Town of Hilton Head Island Regular Design Review Board Meeting

October 27, 2015

AGENDA

**Town of Hilton Head Island
Design Review Board
Minutes of the Tuesday, October 13, 2015 Meeting
1:15p.m. – Benjamin M. Racusin Council Chambers**

GRAVES WAREHOUSE
 19 DUNNAGEN'S ALLEY
 HILTON HEAD ISLAND, SC

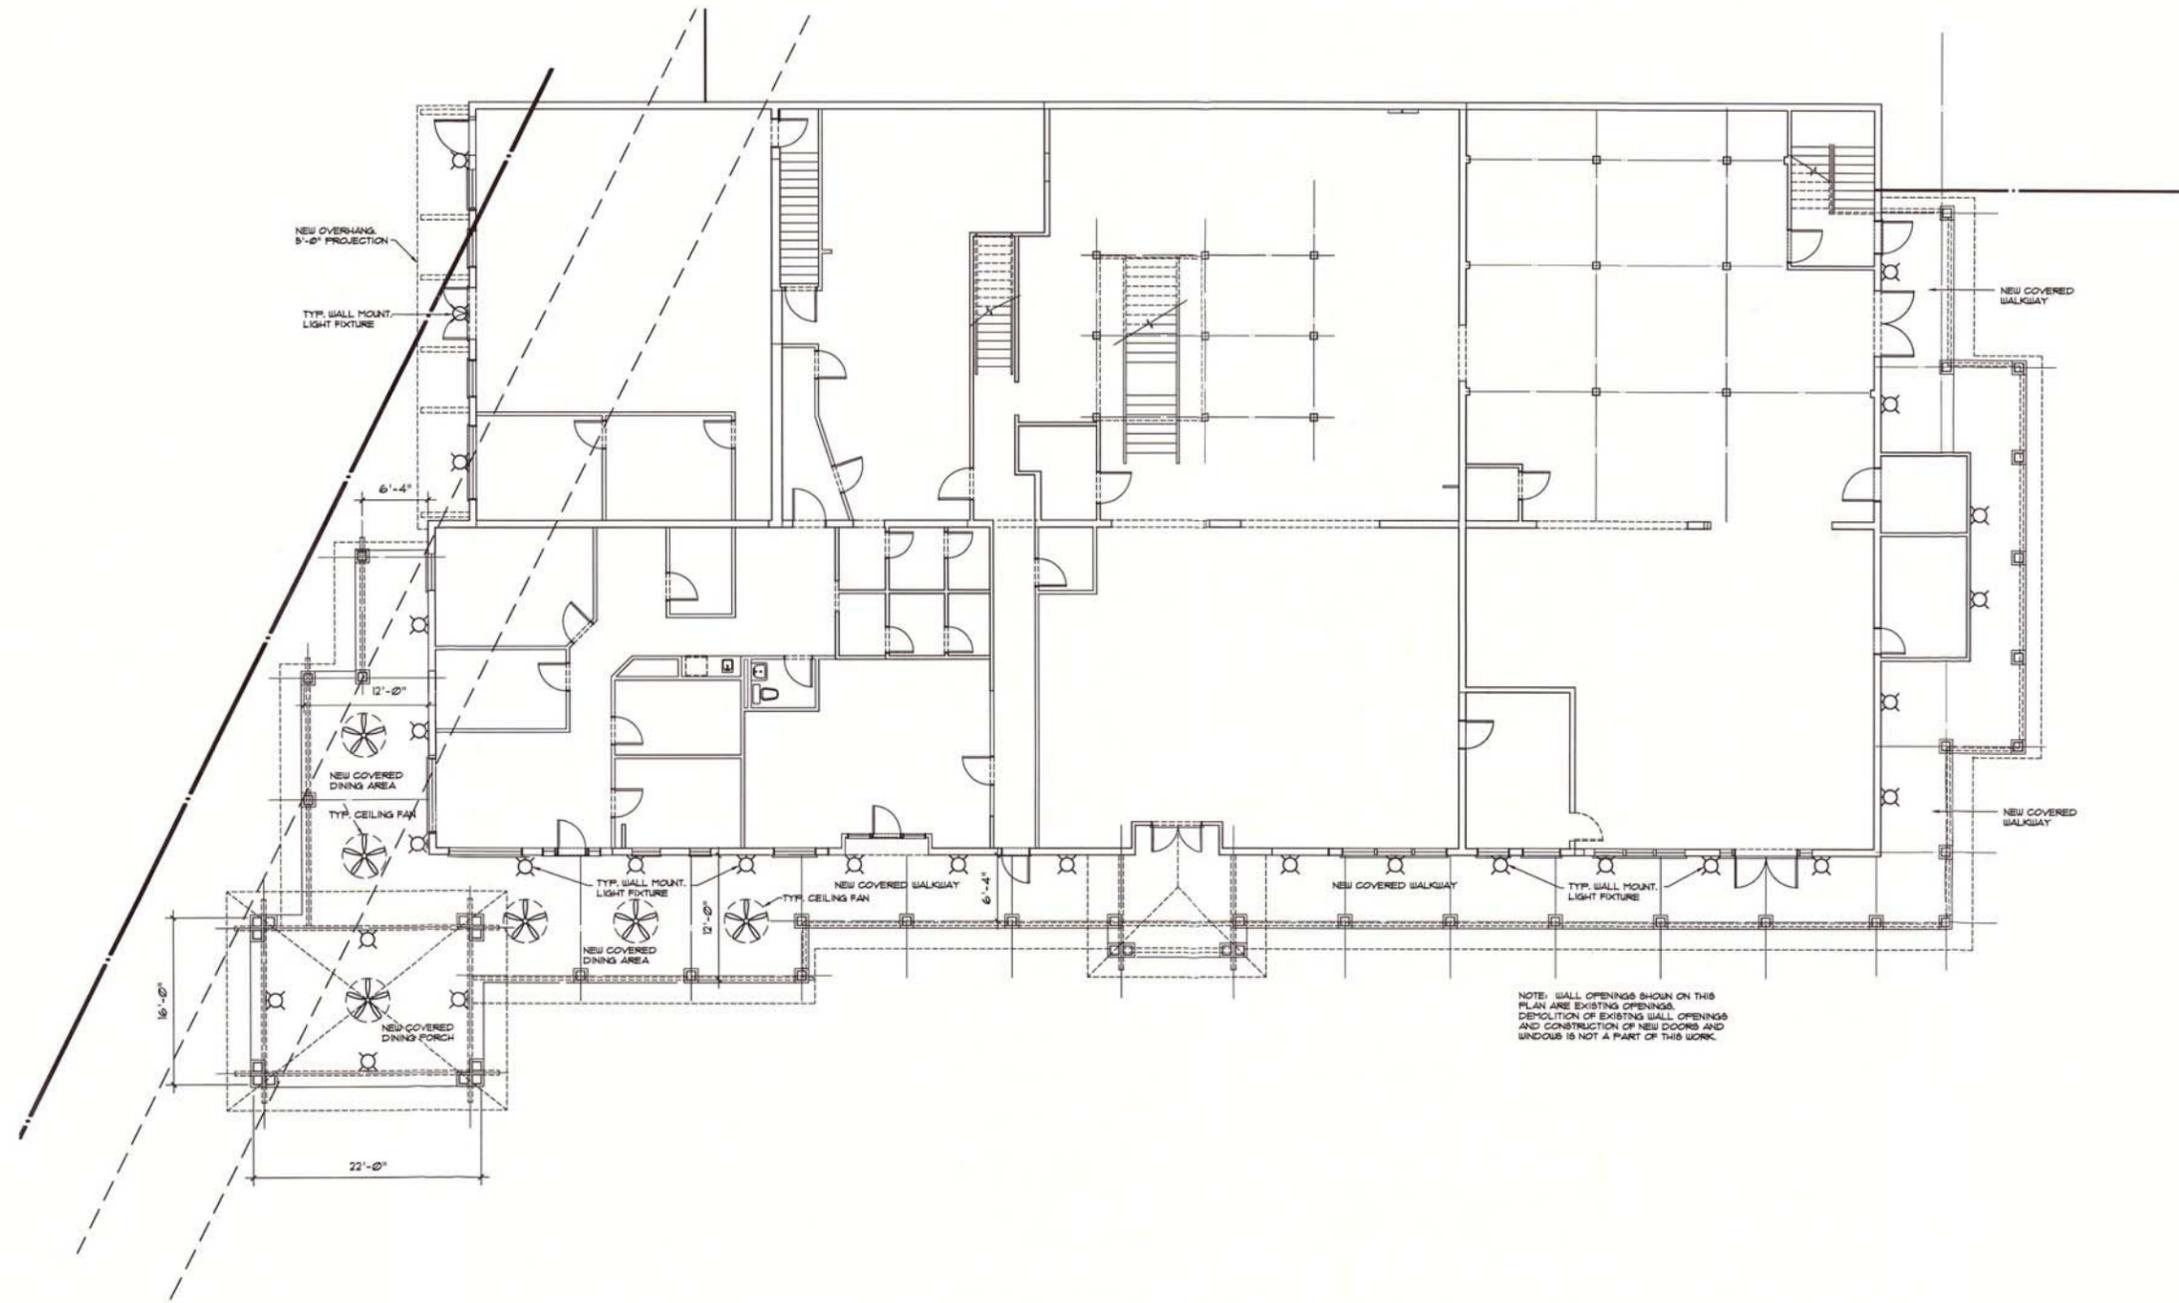
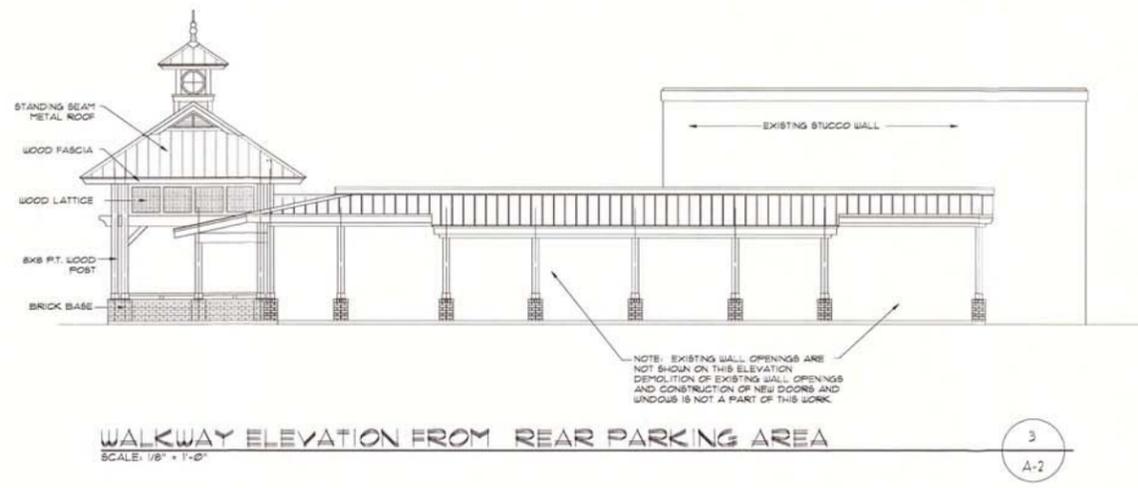
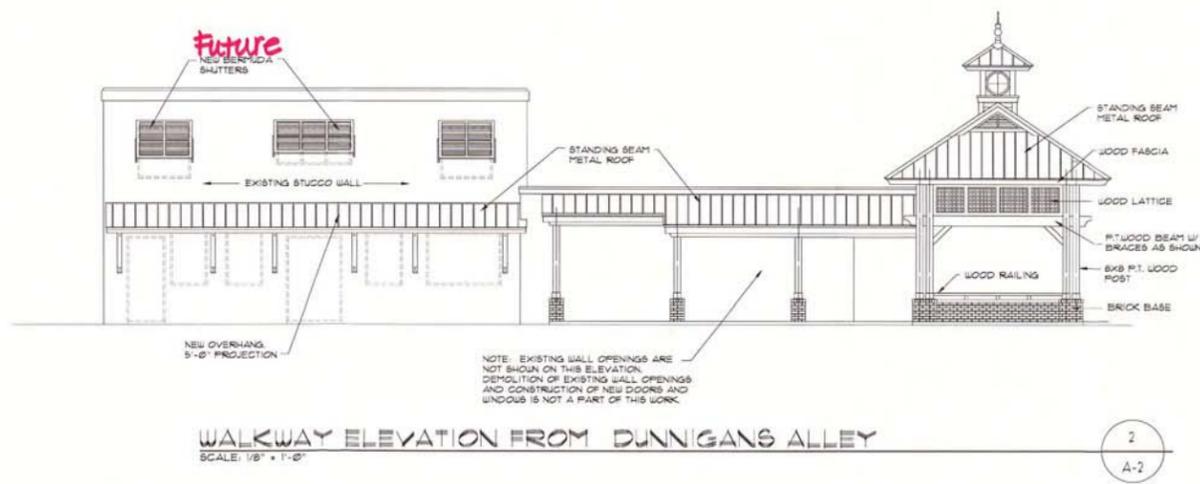
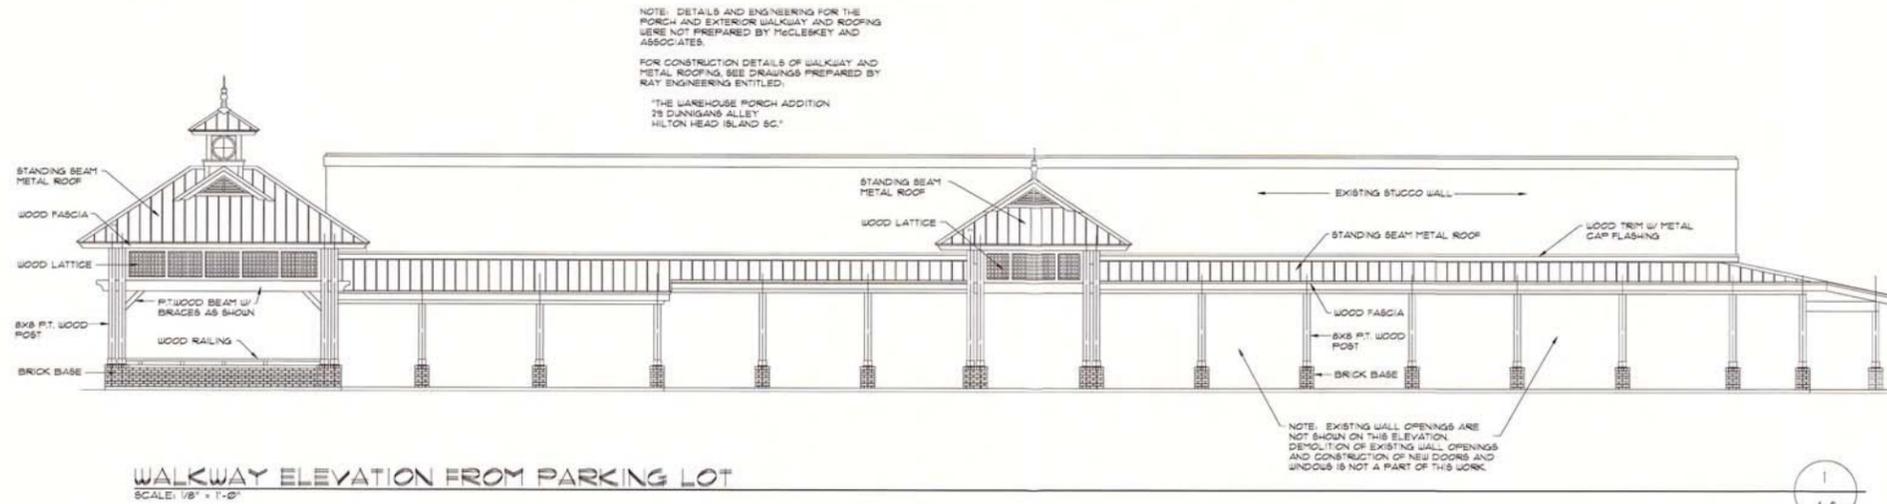
1. Consider repainting building before addition of covered walkway as building currently contains multiple colors.
2. Provide manufacturer's cut sheets for all exterior lighting.
3. Suggest more variety in landscape plan, specifically in lieu of (38) Ligustrum.
4. Provide details or manufacturer's cut sheets for planters including landscape plan indicating proposed landscape material.

Building permit plans review notes that the building is currently split in two by a fire wall. The rear portion of the building is sprinklered. The applicant has the option to extend the fire wall through the canopy addition and sprinkler just the rear portion of the canopy or they can sprinkler the entire structure at this time. If they choose to extend the fire wall, this wall will change the appearance drastically.

A New Restaurant:
WREN
 Building 110 Shelter Cove Towne Center
 38 Shelter Cove Lane
 Hilton Head Island, SC 29928
 PROP. I.D.:

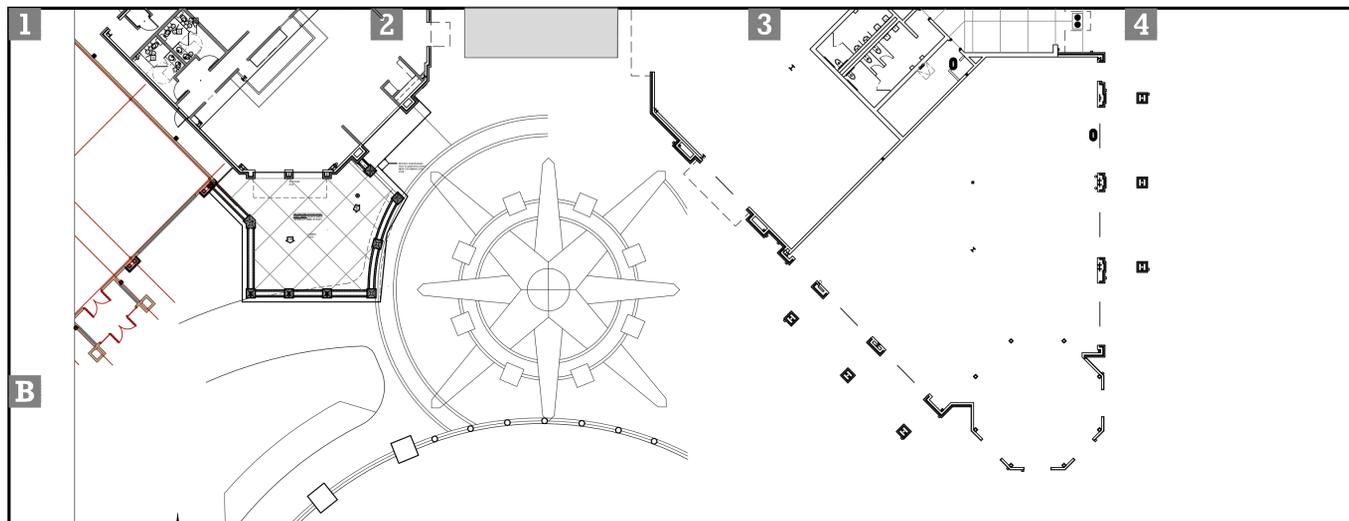
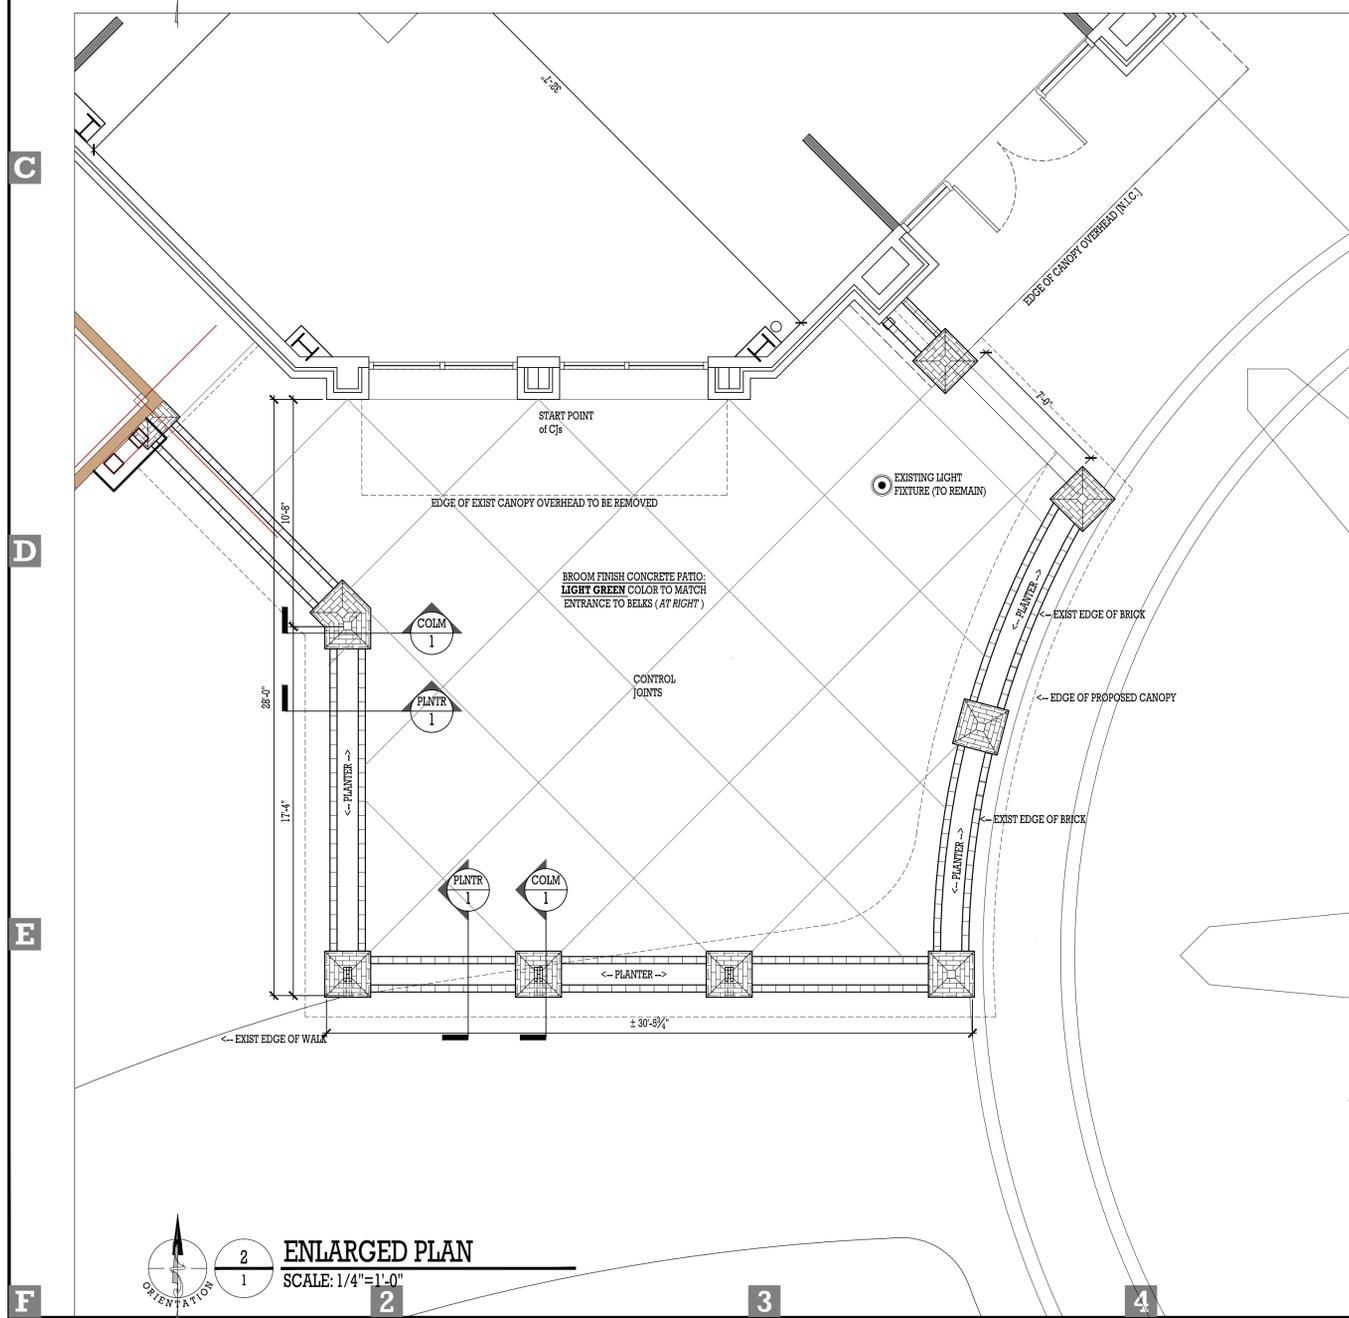
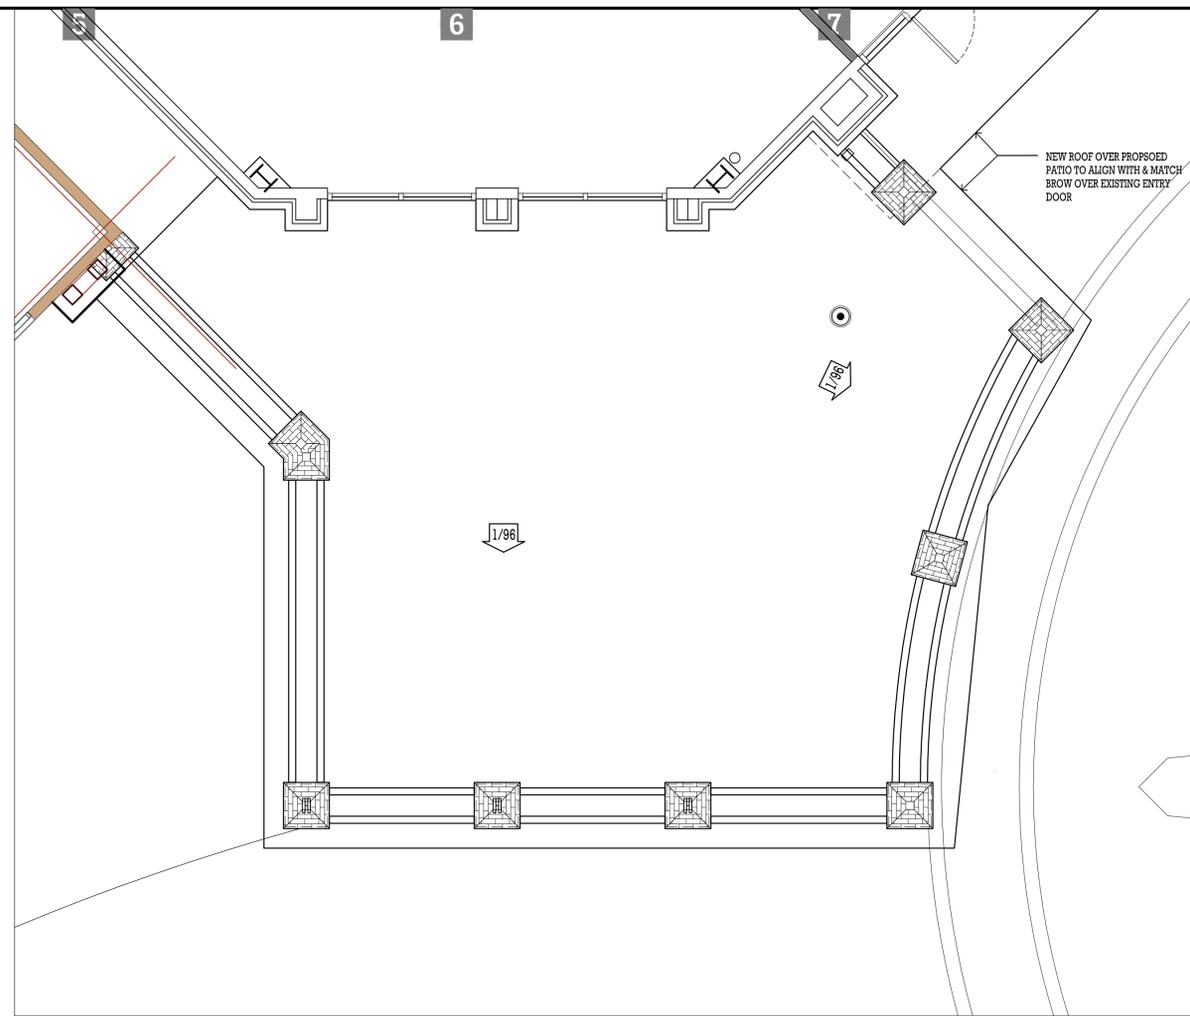
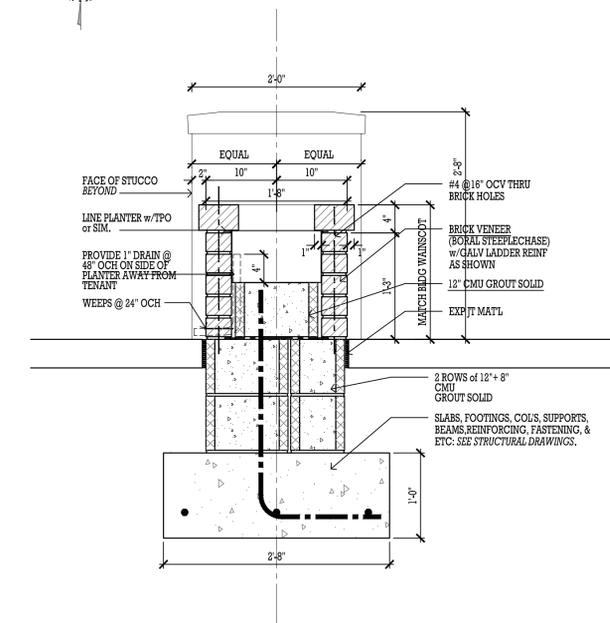
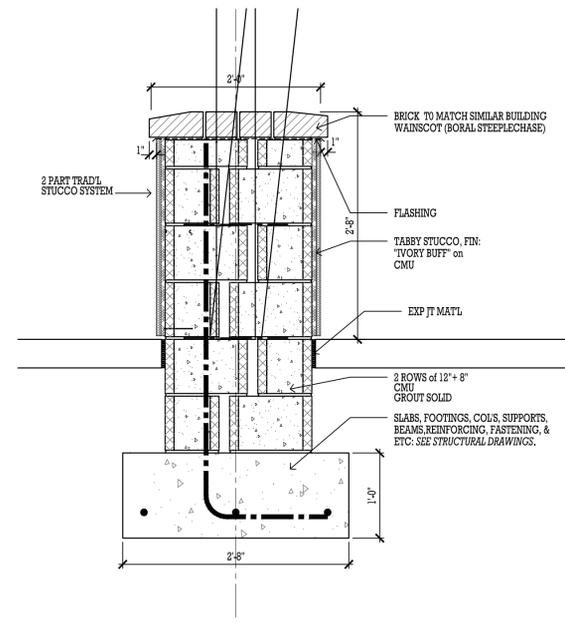
Applicant proposes to revise previously approved patio to shift away from front of adjacent building. Patio design including enclosure walls are in keeping with Design Guide and previous approvals. Per previous DRB conditions of approval a more consistent small hedge is to be planted in planters surrounding patio. A roof structure to match existing brow over entry door is proposed over patio for covered outdoor seating.
